Lower Thames Crossing

9.152 Responses to the Examining Authority's ExQ2 Appendix G – 11. Biodiversity (Part 1 of 2)

DATE: October 2023
DEADLINE: 6

Planning Inspectorate Scheme Ref: TR010032
Examination Document Ref: TR010032/EXAM/9.152

Contains Ordnance Survey data. © Crown copyright and database rights 2022. Ordnance Survey 100030649

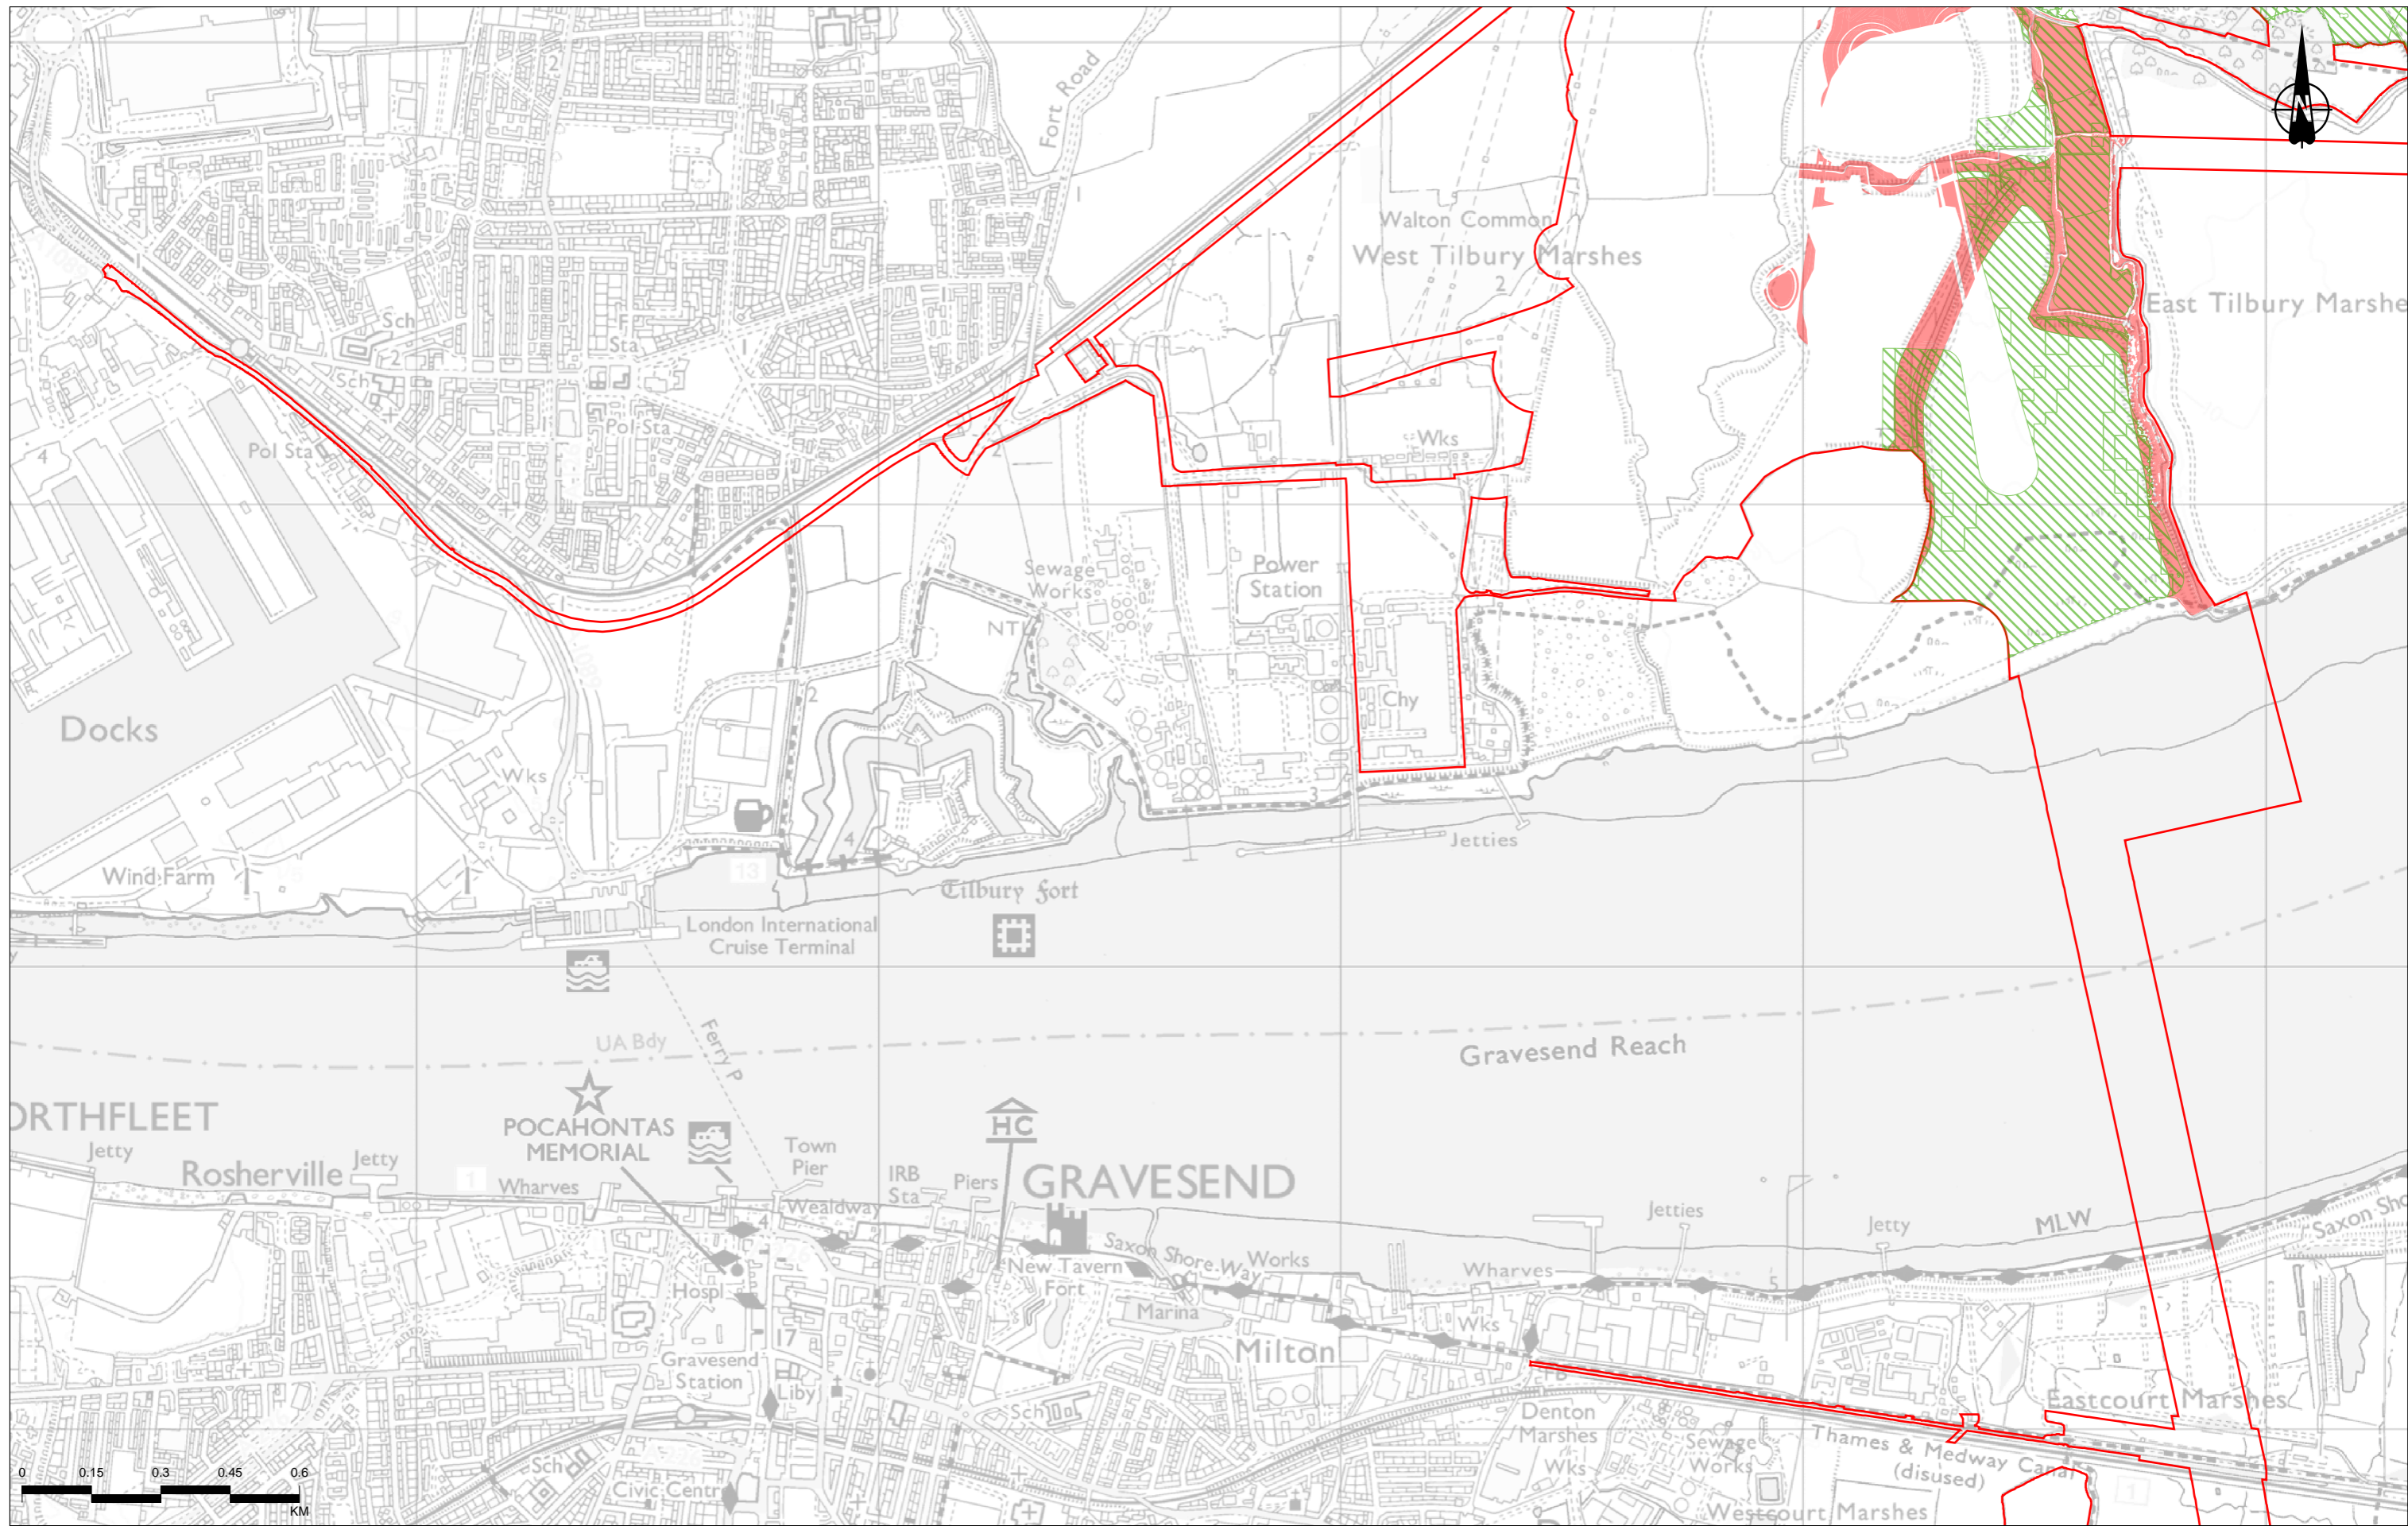
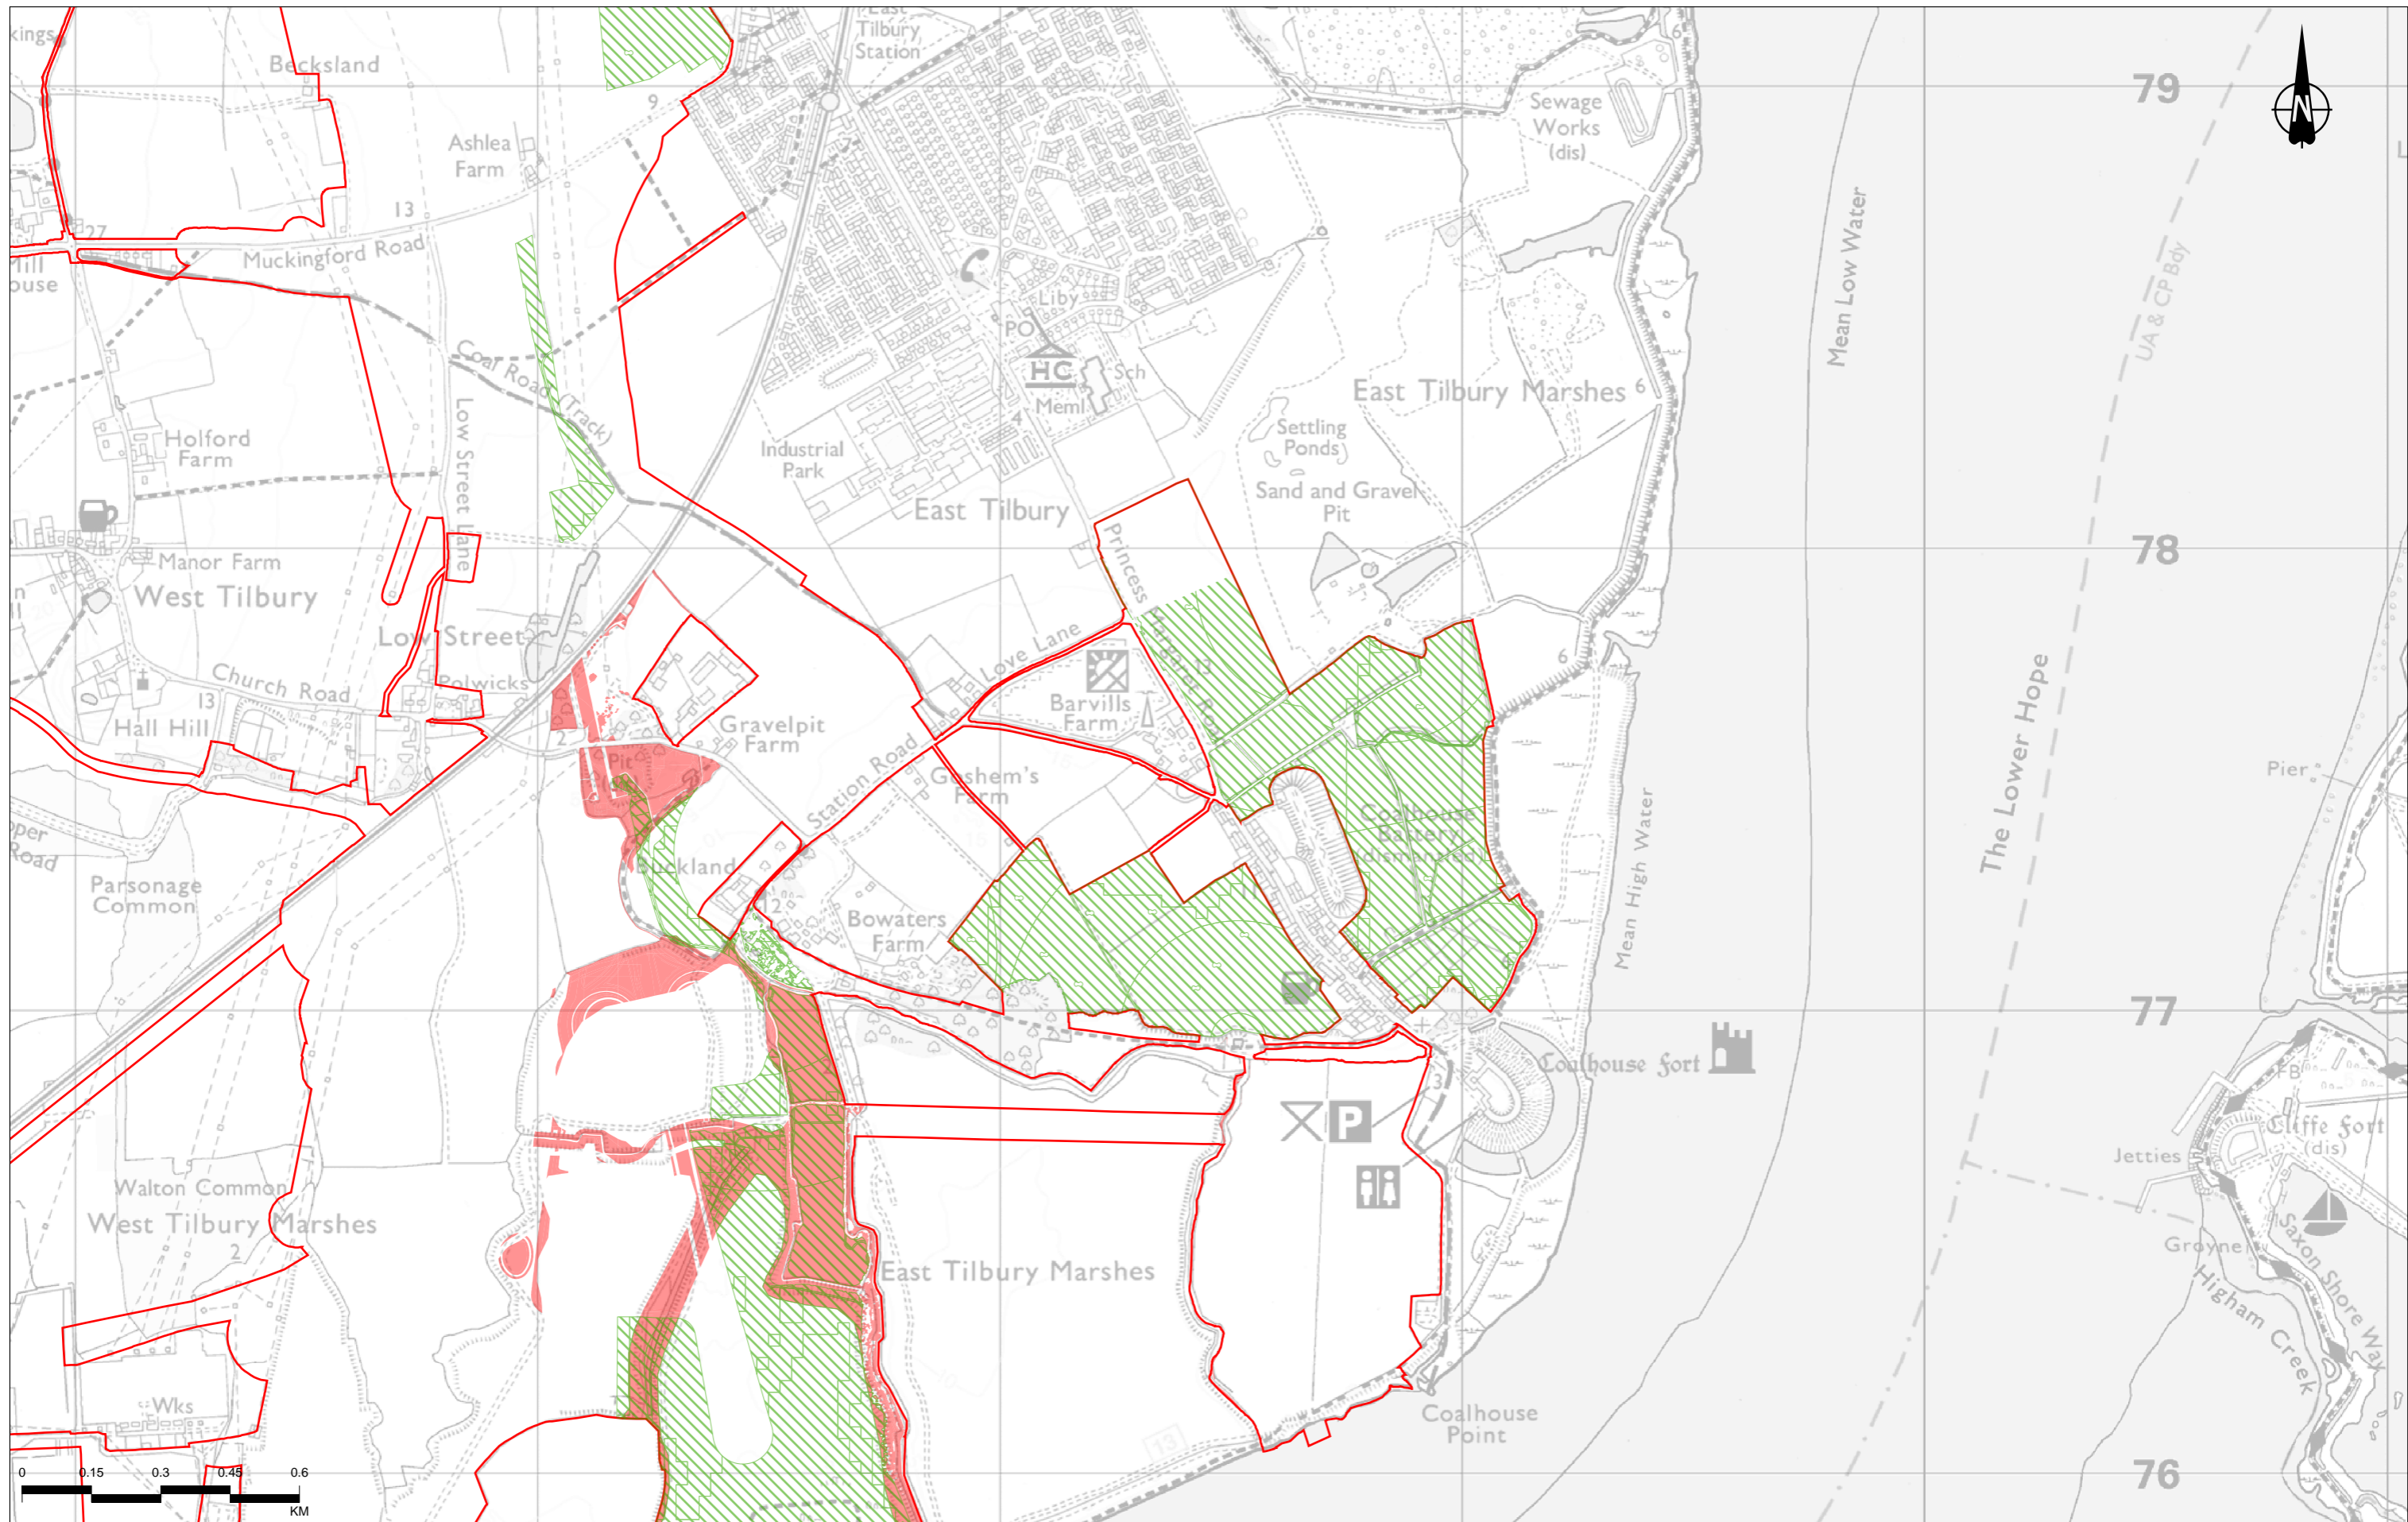
ExQ2_Q11.3.2	Applicant	<p>Offsetting</p> <p>The document reference 9.90 Mitigation Route Map [REP4-203] is noted, but the ExA would like to see a simple graphical representation / location plan to understand which area(s) of habitat are being created for particular impacts; such an approach will help provide clarity that the impacts are fully mitigated or compensated for. The detail provided in Tables 8.31 (south of the River Thames) and 8.35 (north of the River Thames) of Chapter 8 Terrestrial Biodiversity of the Environmental Statement [APP-146] are noted, but it continues to be difficult to track where the individual areas of habitat impacted are mitigated or compensated for on the ground within the submitted documents.</p> <p>Response:</p> <p>The Applicant has provided simple graphical representations which illustrate the location and extent of habitat creation proposals and the corresponding Project impacts for which they provide mitigation and compensation. These cover the following key habitat types:</p>

PINS ID	Question to:	Question / Response
		<ul style="list-style-type: none"> • Woodland (excluding designated woodland loss and compensation which is reported in ES – Figure 8.33: Ancient Woodland Impacts [APP-294]) • Open mosaic habitat • Grassland (excluding amenity and poor semi-improved grassland of low biodiversity value) • Hedgerows <p>These figures are provided in the Figures Annex to this document. We are also working to produce a similar map showing wetland habitats which, due to the range of wetland habitats involved, will be submitted at Deadline 7.</p>
ExQ2_Q11.3.3	Applicant	<p>Biodiversity Net Gain (BNG)</p> <p>In a similar manner to ExQ2 Q11.3.2 of this set of questions, the ExA requests the Applicant provide a graphical representation / location plan in addition to that detailed above showing all areas of environmental improvement included in the BNG metric.</p> <p>Response:</p> <p>The Applicant’s BNG Metric assessment [APP-417] includes all areas of <i>direct habitat loss and creation</i> within the Order Limits, with the following exceptions:</p> <ul style="list-style-type: none"> • Ancient woodland habitat lost (6.87ha) as a result of the Project is excluded from the baseline assessment. • Wood-pasture parkland habitat lost (0.07ha) as a result of the Project is excluded from the baseline assessment. • Bespoke compensation for ancient woodland loss (81ha) is excluded from the post-intervention assessment. • Nitrogen deposition compensation areas (246ha) are excluded from both the baseline and post-intervention parts of the assessment. <p>Areas of temporary land-take within the Order Limits are included in the BNG Metric assessment. For these areas, there is an assumption in the Metric assessment that the baseline habitat is lost and then re-instated post-construction to the same habitat type and condition as in the baseline.</p> <p>These explanatory notes support the Applicant’s submission of graphical representations / location plans which the Applicant commits to issuing by Deadline 7, so that it is clear which features on the plans are included in the BNG Metric.</p>
